# **REPORT ON WESTERN ROAD**

## REPORT ON WESTERN ROAD – TREE PROPOSALS

## Western Road

**Outside No 53: SA. Recommend Replacement: Airspade In Agreement**

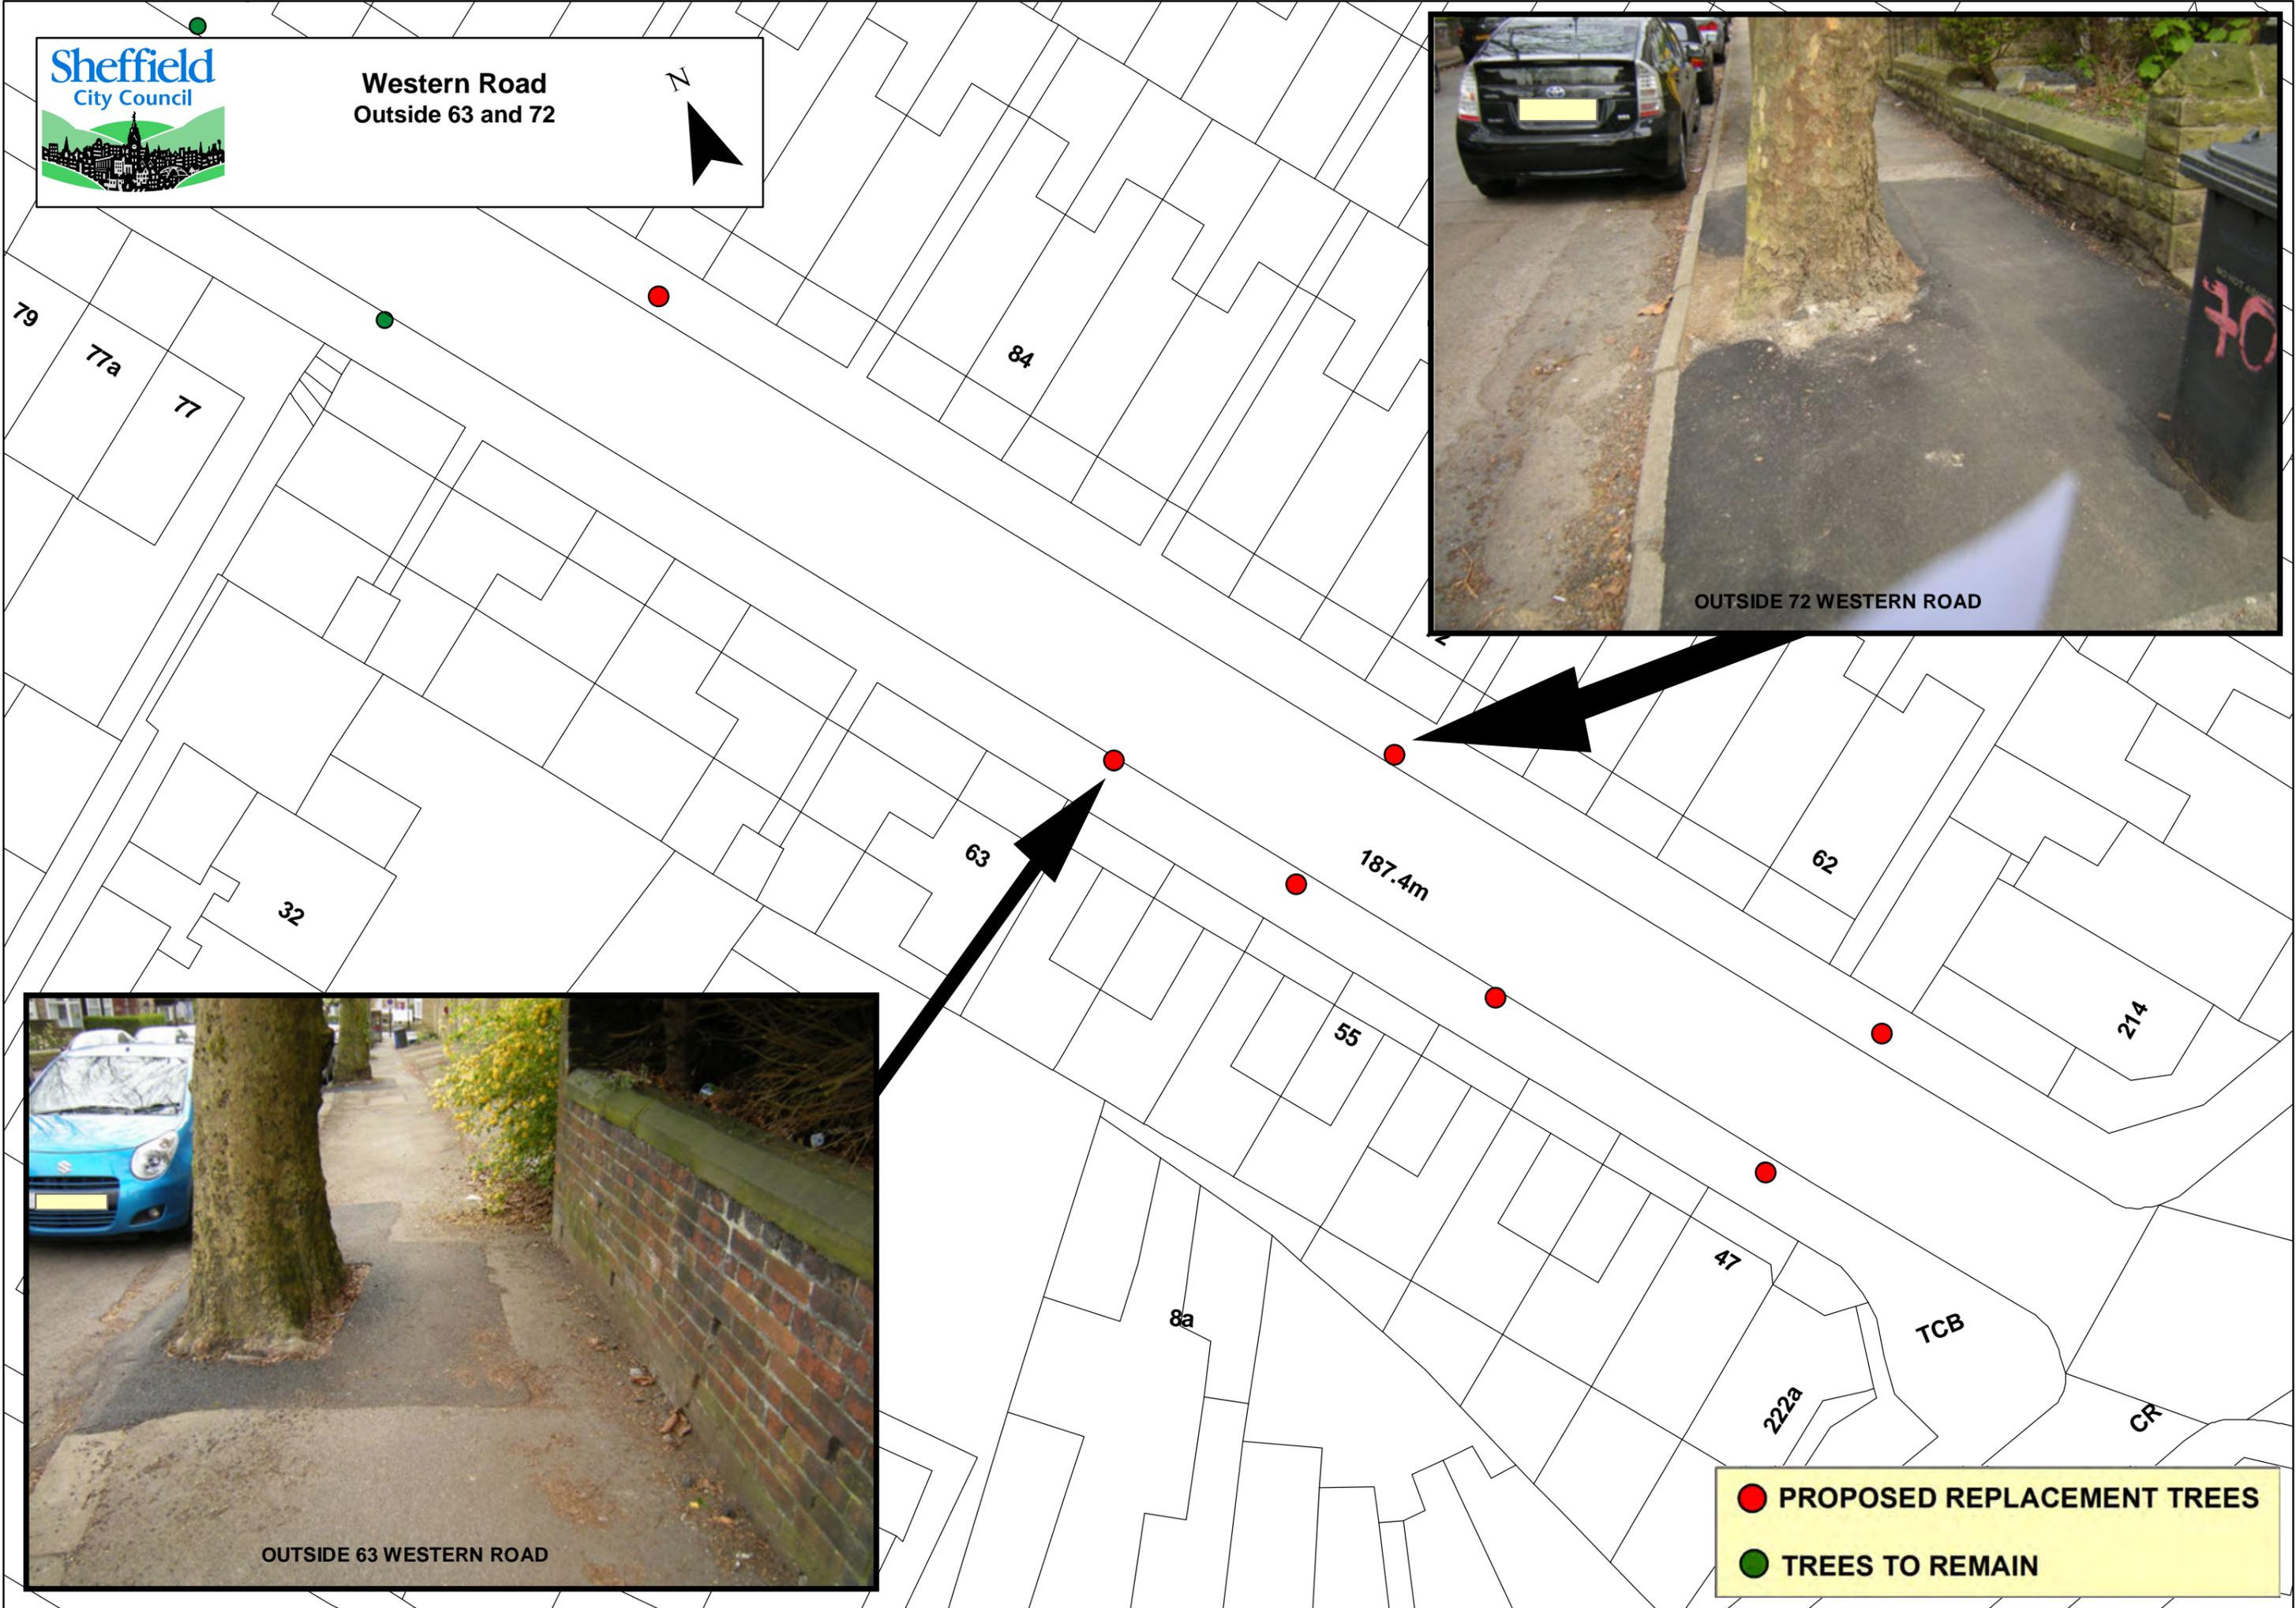
Cannot install full or half kerb due to buttress which was suggested by ITP. Risk of vehicle strike damaging existing wounds allowing entry of pathogens: Independent Airspade report recommends replacement.

**The root continues to grow into the carriageway and will get damaged when surfacing is completed. Proceed as planned with replacement**

## **Outside No. 63: SA. Recommend Replacement: Airspade in Agreement:**

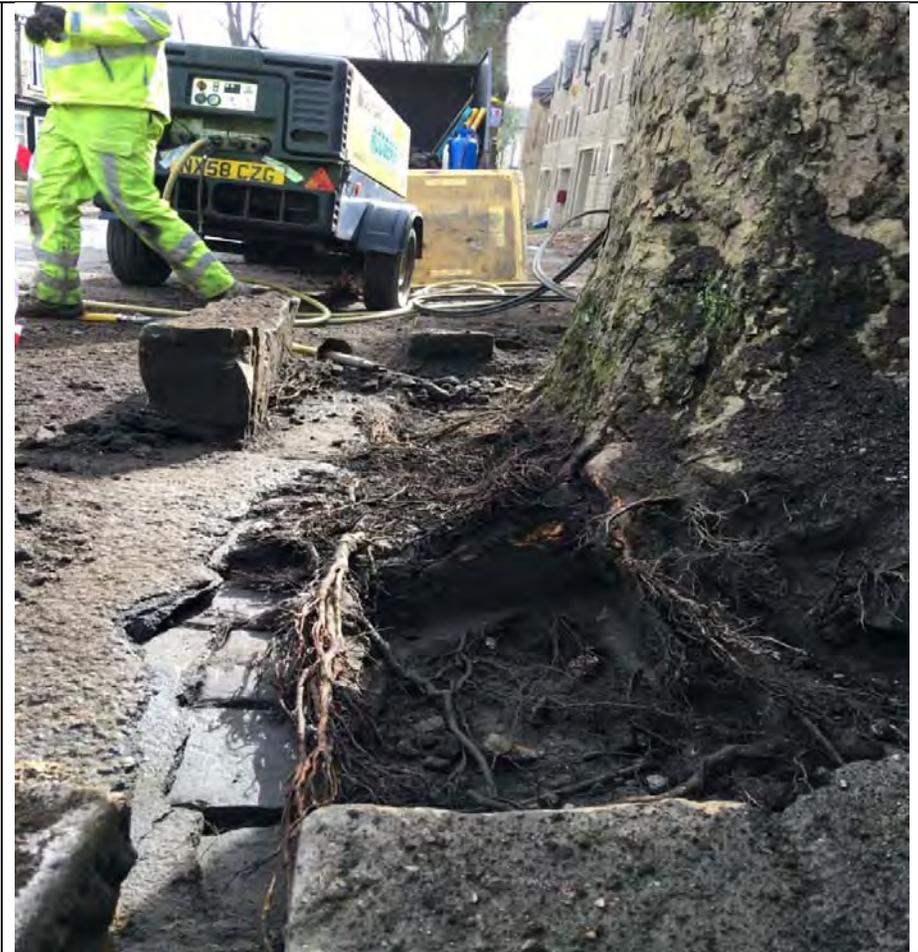
Replacement only option - Kerb displaced, unable to reset or provide half kerb. Roots continuing to trace under carriageway causing significant structural damage. Footway already ramped and damaged by shallow roots.

**OPP No. 87 Additional**

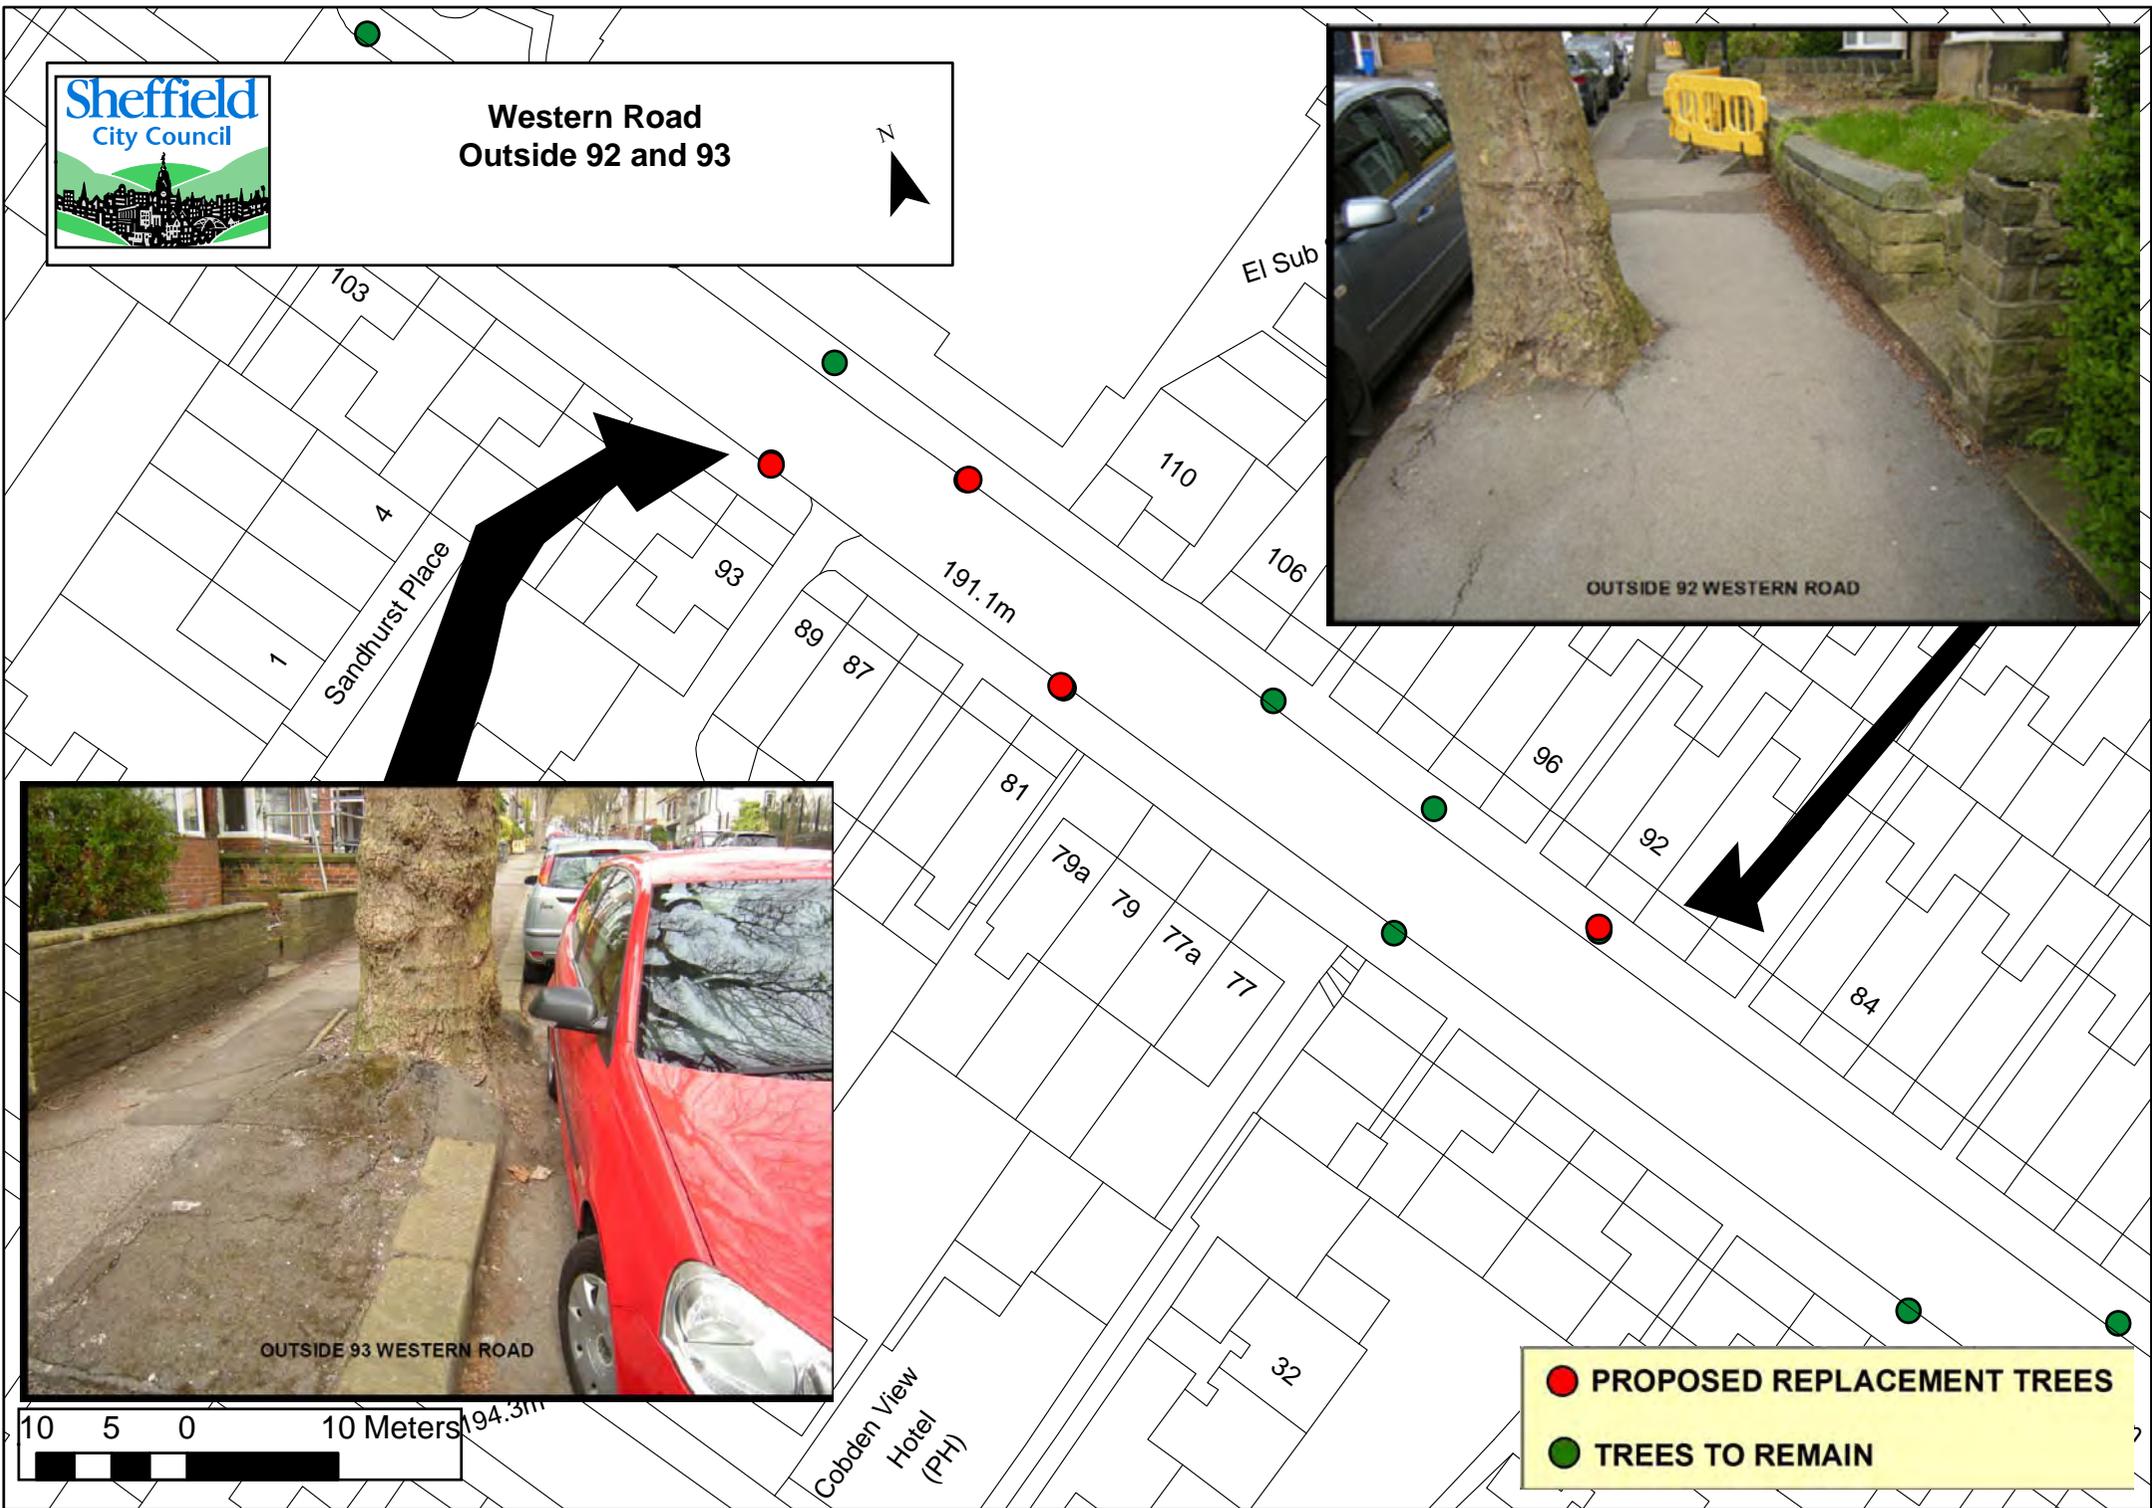
**Temporary repair in Bitmac to cover roots into carriageway. Evidence of roots tracing towards property. Previous thin kerb already failed and removed due to roots, unable therefore to replace half kerb .**
